City of Hamilton PUBLIC WORKS COMMITTEE AGENDA

Meeting #: 21-016

Date: November 1, 2021

6.1. Update to Hamilton's Solid Waste Collection Design Guidelines for Developments (Item 8.2) (For today's meeting)

3.5 DESIGN REQUIREMENTS FOR MULTI-RESIDENTIAL BUILDINGS

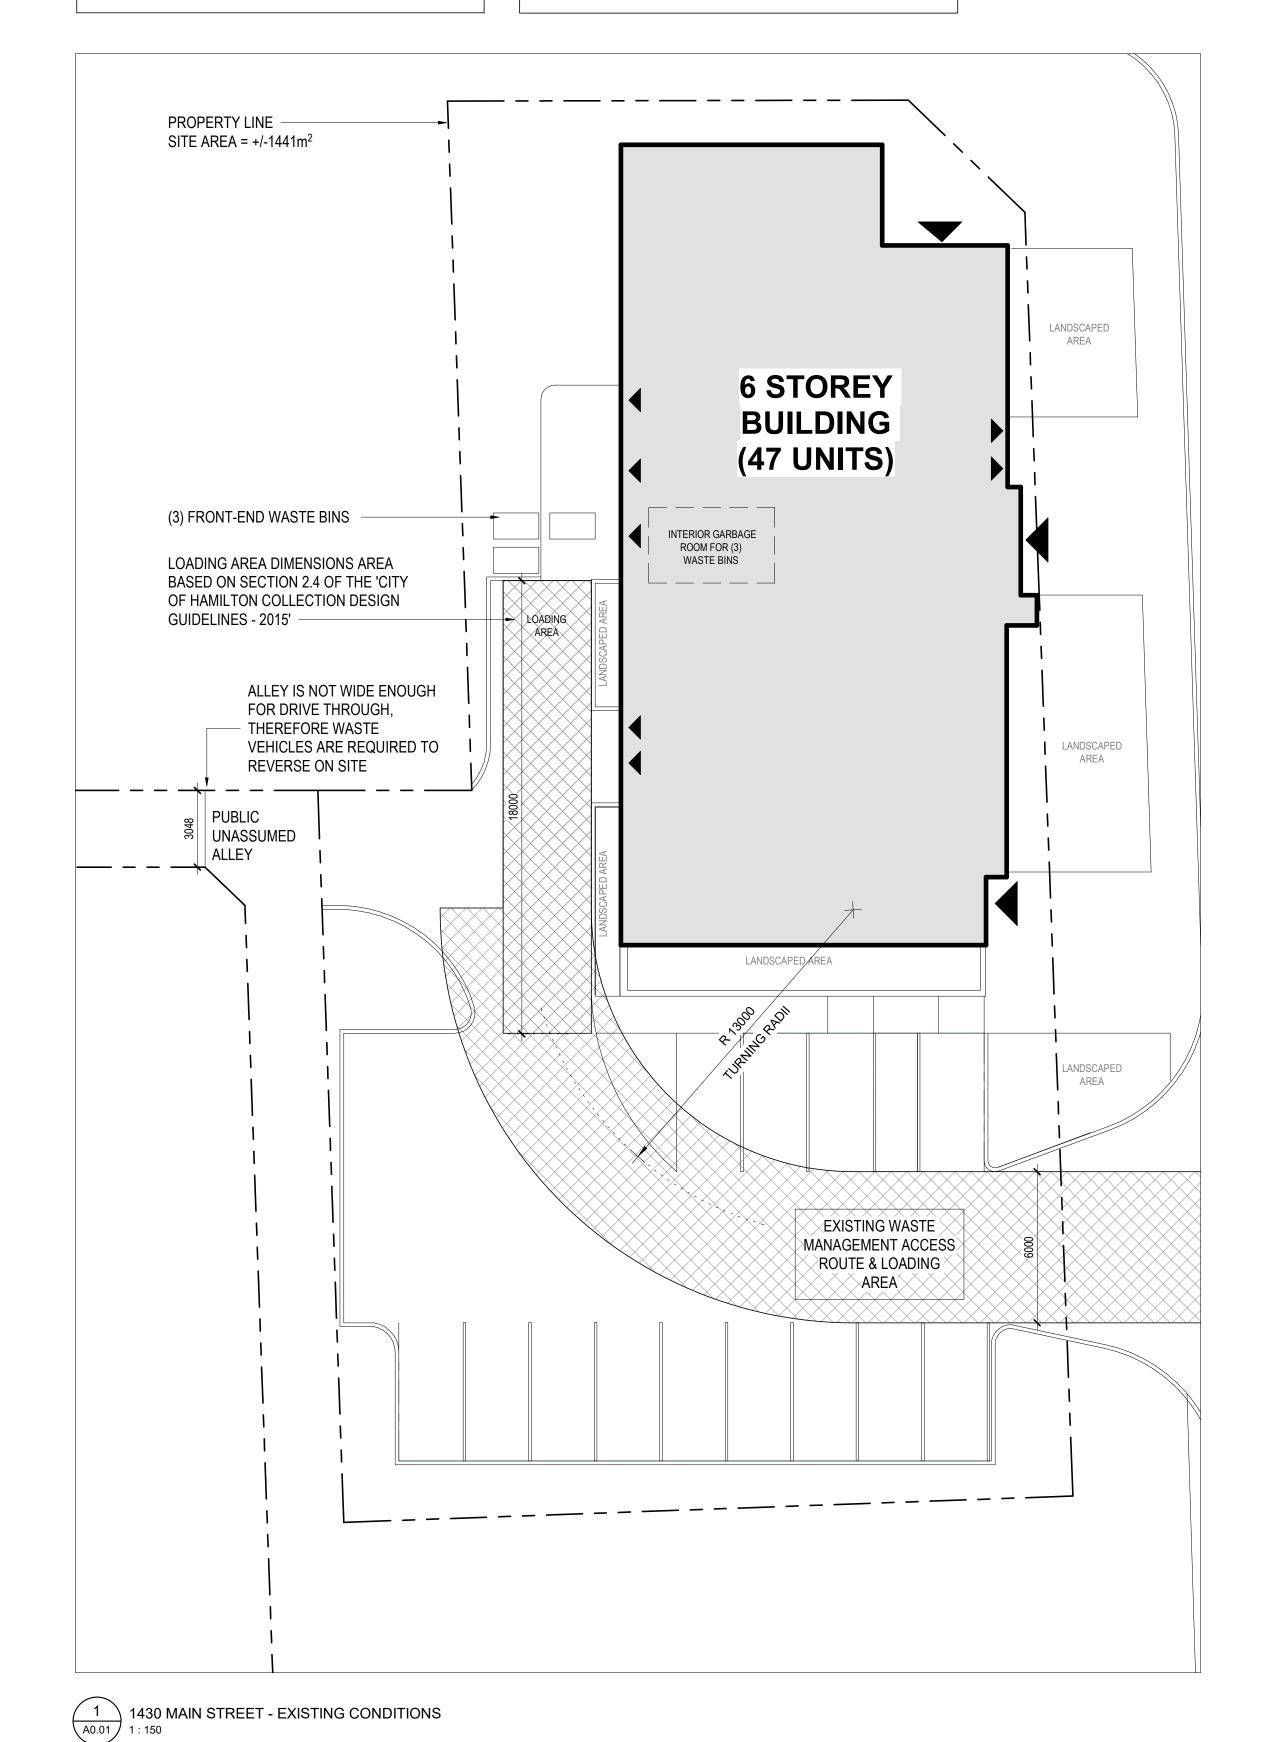
- 6 STOREYS = SMALL MULTI-RESIDENTIAL BUILDING
 - FRONT END LOADING FOR GARBAGE
 - (3) WASTE BINS (5 m² STORAGE EACH) BASED ON 'TABLE 7: NUMBER OF GARBAGE CONTAINERS FOR MULTI-RESIDENTIAL **BUILDINGS'**
- (3 X 5m²) = 15m² INTERIOR STORAGE SPACE

SITE RESULTS DUE TO PROPOSED DRAFT HAMMERHEAD

TOTAL LOSSES:

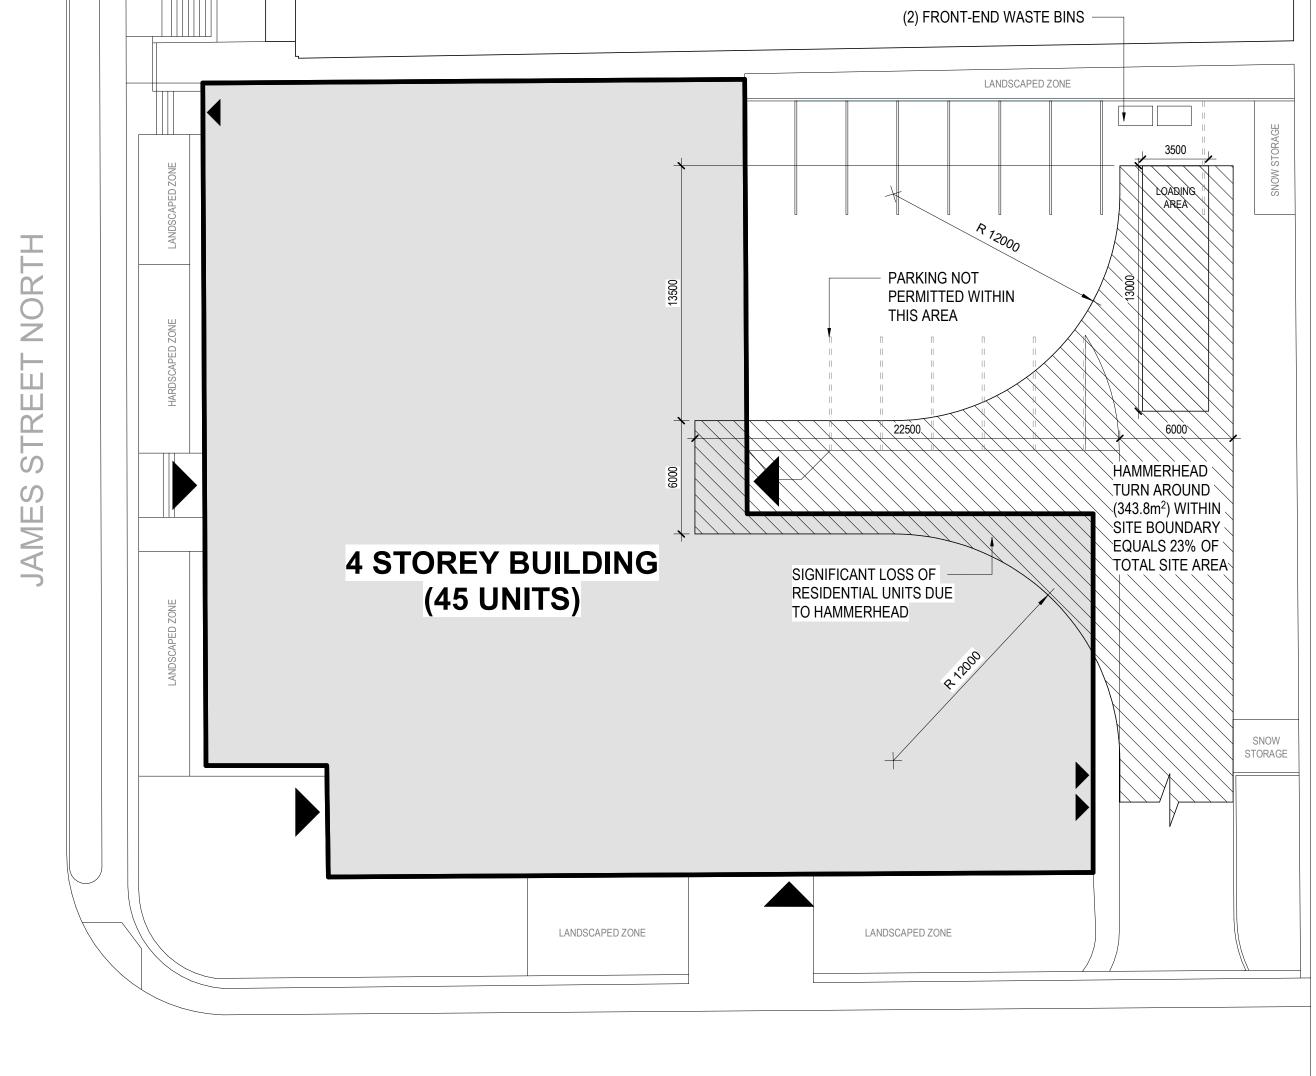
- SIGNIFICANT LOSS OF PARKING DUE TO HAMMERHEAD SPACE REQUIREMENTS
- REDUCTION OF BUILDING AREA AND UNITS DUE TO HAMMERHEAD SPACE REQUIREMENTS
- GOALS FOR INTENSIFICATION WOULD BE REDUCED DUE TO PROPOSED HAMMERHEAD REQUIREMENTS

45 UNITS IS REDUCED TO 41 UNITS BASED ON **BUILDING AREA CLEAR OF HAMMERHEAD**

16 PARKING SPACES IS REDUCED TO 7

SITE RESULTS DUE TO PROPOSED DRAFT HAMMERHEAD

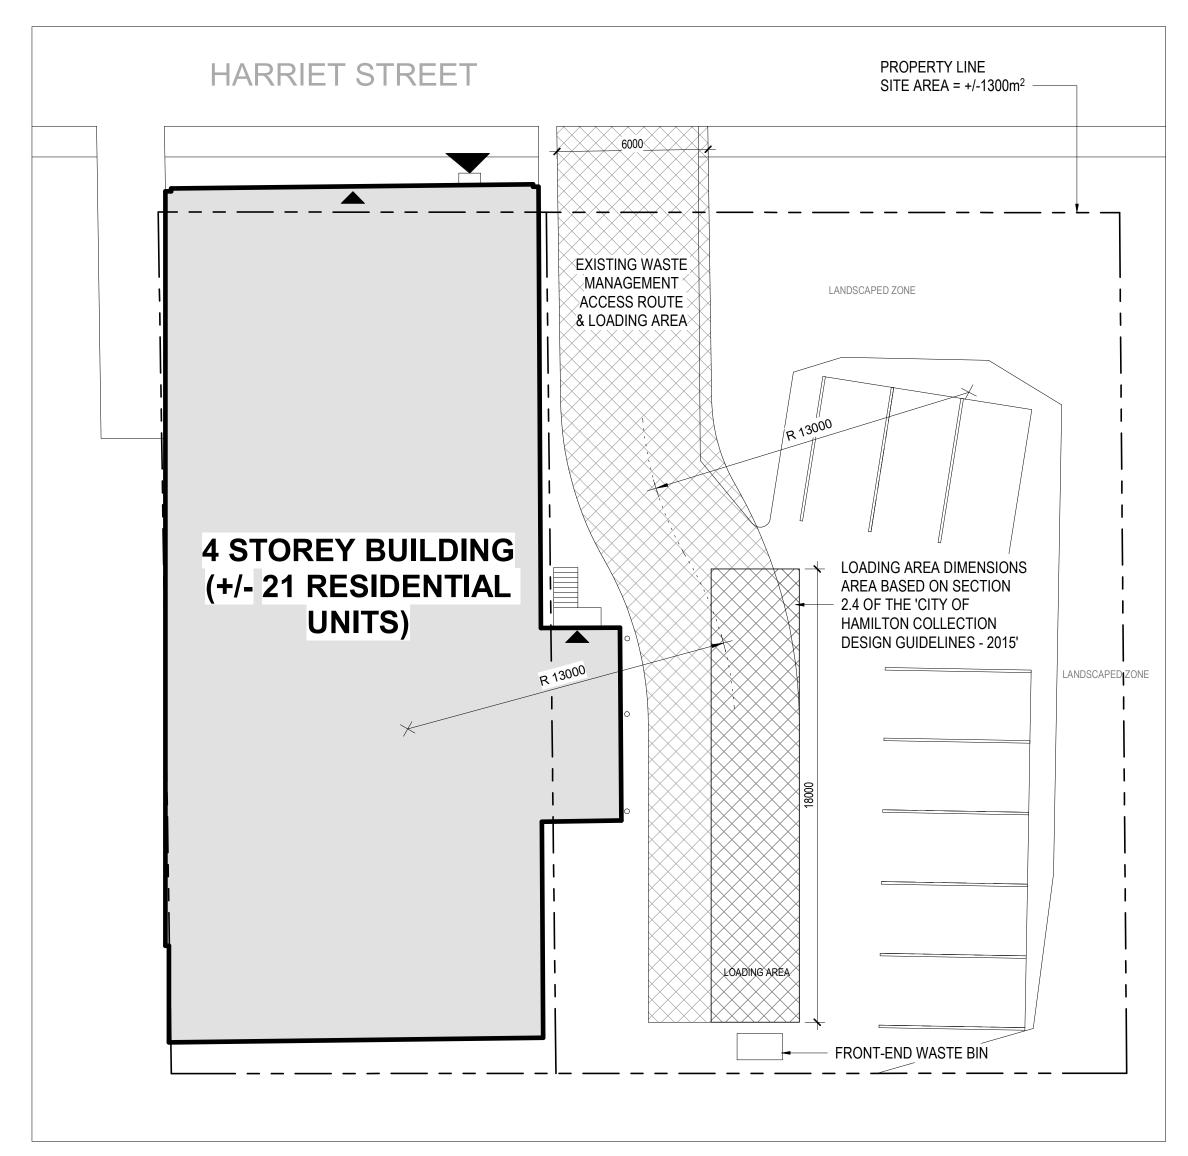
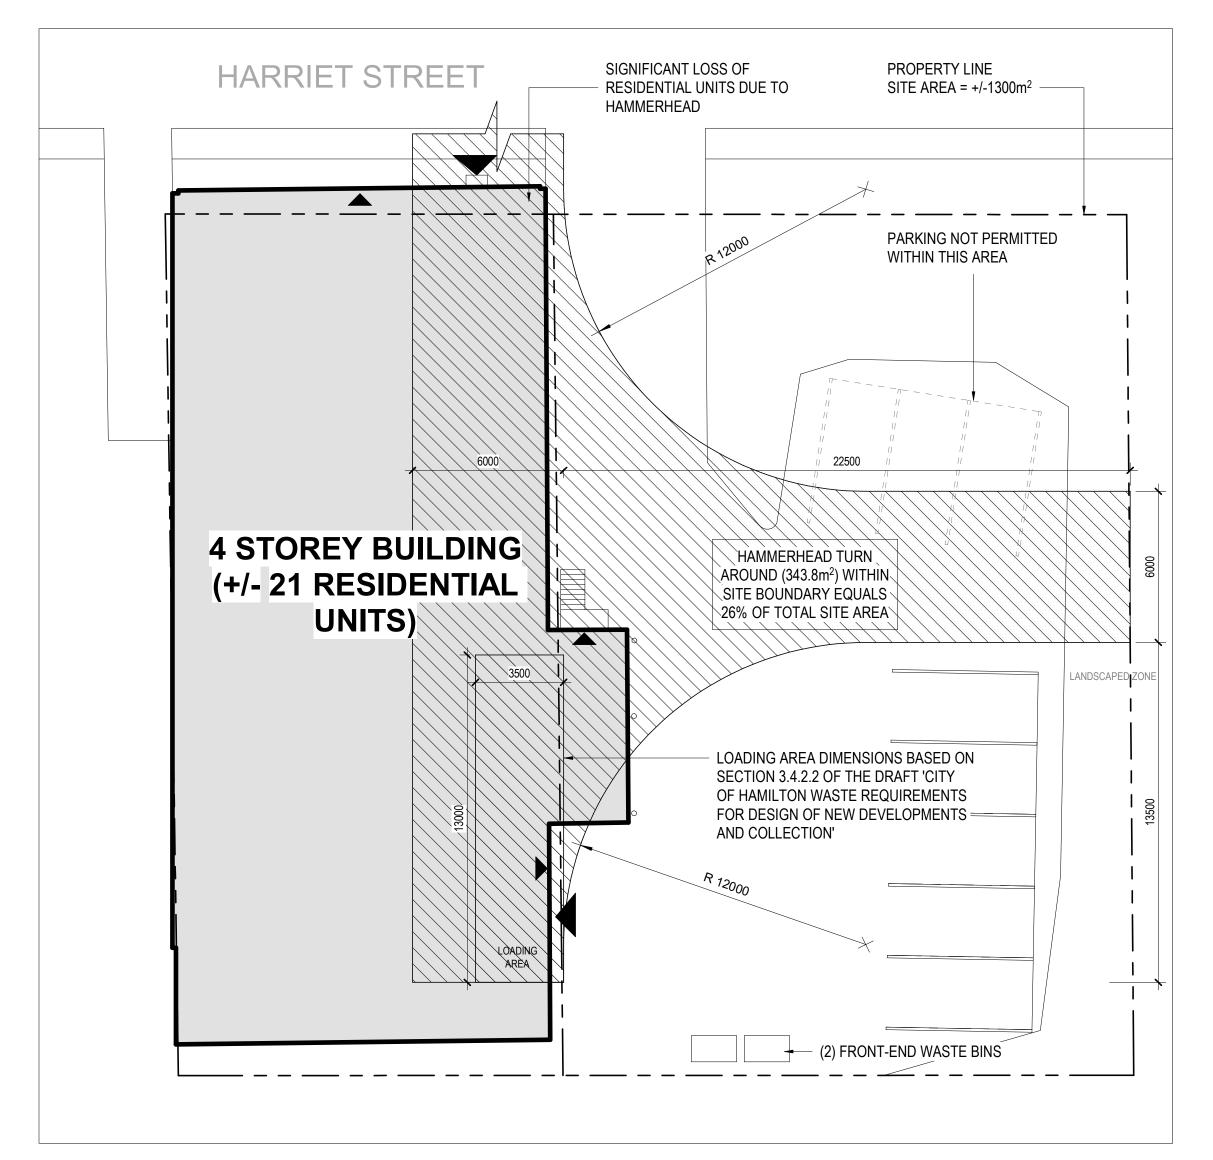
- THE CURRENT PARKING CONSTRAINS WOULD ENCOUNTER SIGNIFICANT LOSS OF PARKING CAPACITY DUE TO HAMMERHEAD SPACE REQUIREMENTS
- REDUCTION OF BUILDING AREA AND UNITS DUE TO HAMMERHEAD SPACE REQUIREMENTS (12 UNITS LOST)
- GOALS FOR INTENSIFICATION WOULD BE REDUCED
 DUE TO PROPOSED HAMMERHEAD REQUIREMENTS

POTENTIAL FOR 21 UNITS IS REDUCED TO 9
UNITS BASED ON BUILDING AREA CLEAR OF
HAMMERHEAD

MAJOR DEMOLITION TO EXISTING BUILDING WOULD BE REQUIRED

1 SITE PLAN - Isabella (Ottawa)

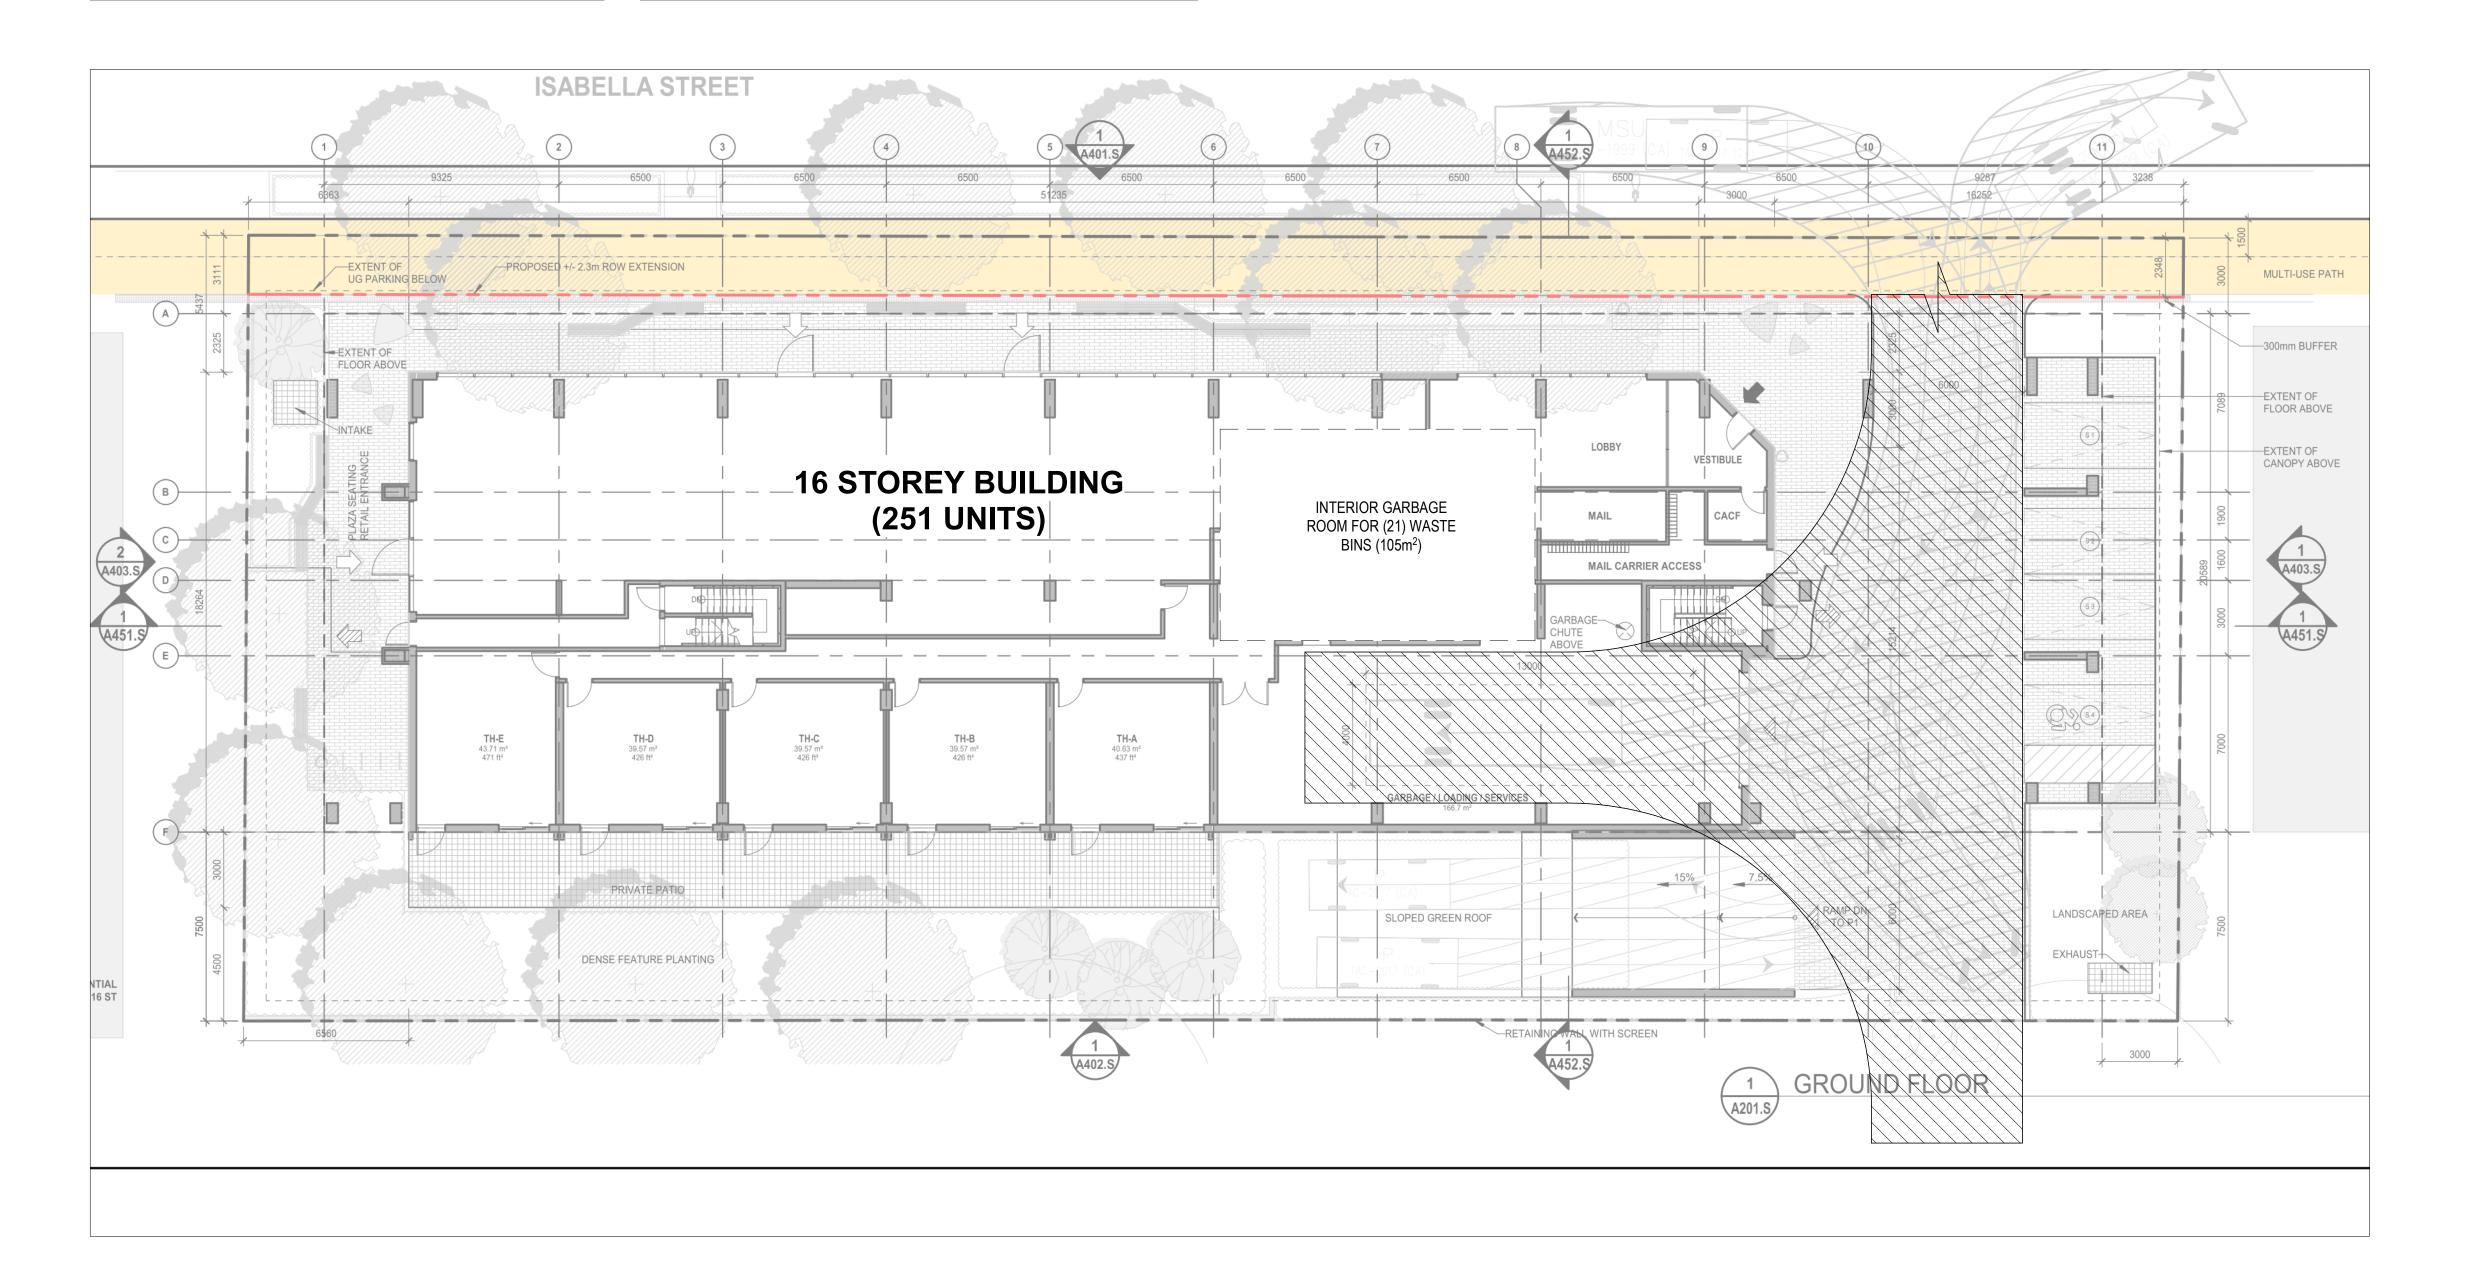
- 16 STOREYS = LARGE RESIDENTIAL
- GARBAGE, RECYCLING AND GREEN CARTS
- >12 GARBAGE CONTAINERS (UNCOMPACTED)
- 6 (+?) GARBAGE CONTAINERS (COMPACTED) 12 RÉCYCLING ORGANIC CONTAINRES
- 3 ORGANIC FRONT END CONTAINERS

- LOSS OF UNITS AND OVERALL BUILDABLE AREA DUE TO REQUIRED HAMMERHEAD
- LOSS OF UNITS DUE TO SPACE REQUIREMENTS FOR INTERIOR GARBAGE STORAGE
- PROJECT WOULD REQUIRE SIGNIFICANT REDESIGN IF PLANNED FOR THE CITY OF HAMILTON

SITE RESULTS DUE TO PROPOSED DRAFT HAMMERHEAD

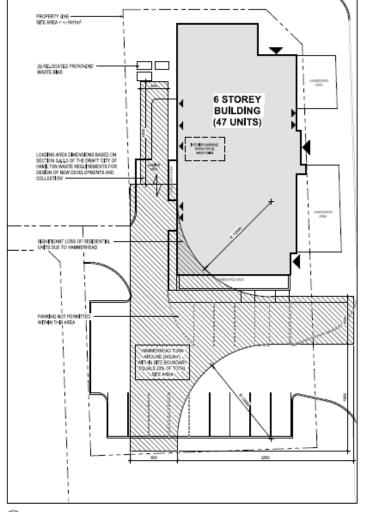
- SIGNIFICANT LOSS OF PARKING DUE TO HAMMERHEAD SPACE REQUIREMENTS (7 SPACES LOST)
- REDUCTION OF BUILDING AREA AND RESIDENTIAL UNITS DUE TO HAMMERHEAD SPACE REQUIREMENTS (MIN. 6 UNITS LOST)
- LOADING AREA IMPEDES EXITING AND EGRESS AT THE REAR OF THE BUILDING
- GOALS FOR INTENSIFICATION WOULD BE REDUCED DUE TO PROPOSED HAMMERHEAD REQUIREMENTS

47 UNITS IS REDUCED BY 6 TO 41 UNITS BASED ON BUILDING AREA CLEAR OF HAMMERHEAD

TOTAL LOSSES:

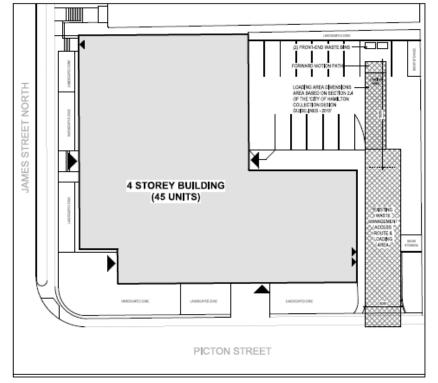
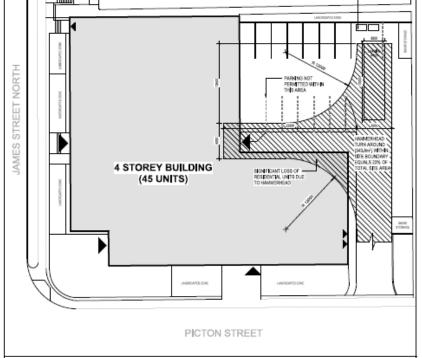
- SIGNIFICANT LOSS OF PARKING DUE TO HAMMERHEAD SPACE
- REDUCTION OF BUILDING AREA AND UNITS DUE TO HAMMERHEAD SPACE REQUIREMENTS
- GOALS FOR INTENSIFICATION WOULD BE REDUCED DUE TO PROPOSED HAMMERHEAD REQUIREMENTS

45 UNITS IS REDUCED TO 41 UNITS BASED ON BUILDING AREA CLEAR OF HAMMERHEAD

16 PARKING SPACES IS REDUCED TO 7

REDUCTION OF PARKING MEANS FURTHER REDUCTION OF UNITS (BASED ON SECTION 5,6 OF BY LAW 05-200 ASSUMING UNITS AS >50m2, AT 0,5 PER UNIT A FURTHER REDUCTION OF 14 UNITS OCCURS)

2 92 JOHN STREET - PROPOSED HAMMERHEAD IMPACTS 1: 280

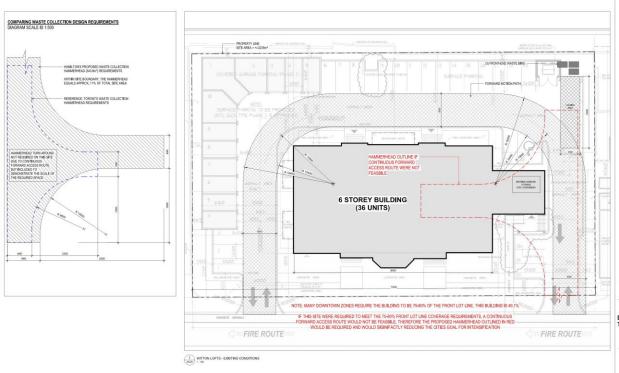
92 JOHN ST

1 SITE PLAN - Isabella (Ottawa)

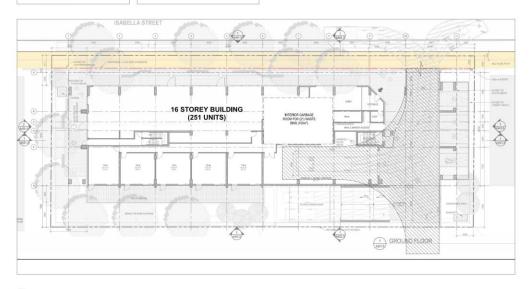
- 16 STOREYS = LARGE RESIDENTIAL
- GARBAGE, RECYCLING AND GREEN CARTS
- >12 GARBAGE CONTAINERS (UNCOMPACTED) 6 (+7) GARBAGE CONTAINERS (COMPACTED) 12 RECYCLING ORGANIC CONTAINERS 3 ORGANIC FRONT END CONTAINERS

- LOSS OF UNITS AND OVERALL BUILDABLE AREA DUE TO REQUIRED HAMMERHEAD
- LOSS OF UNITS DUE TO SPACE REQUIREMENTS FOR INTERIOR GARBAGE STORAGE
- PROJECT WOULD REQUIRE SIGNIFICANT REDESIGN IF PLANNED FOR THE CITY OF HAMILTON
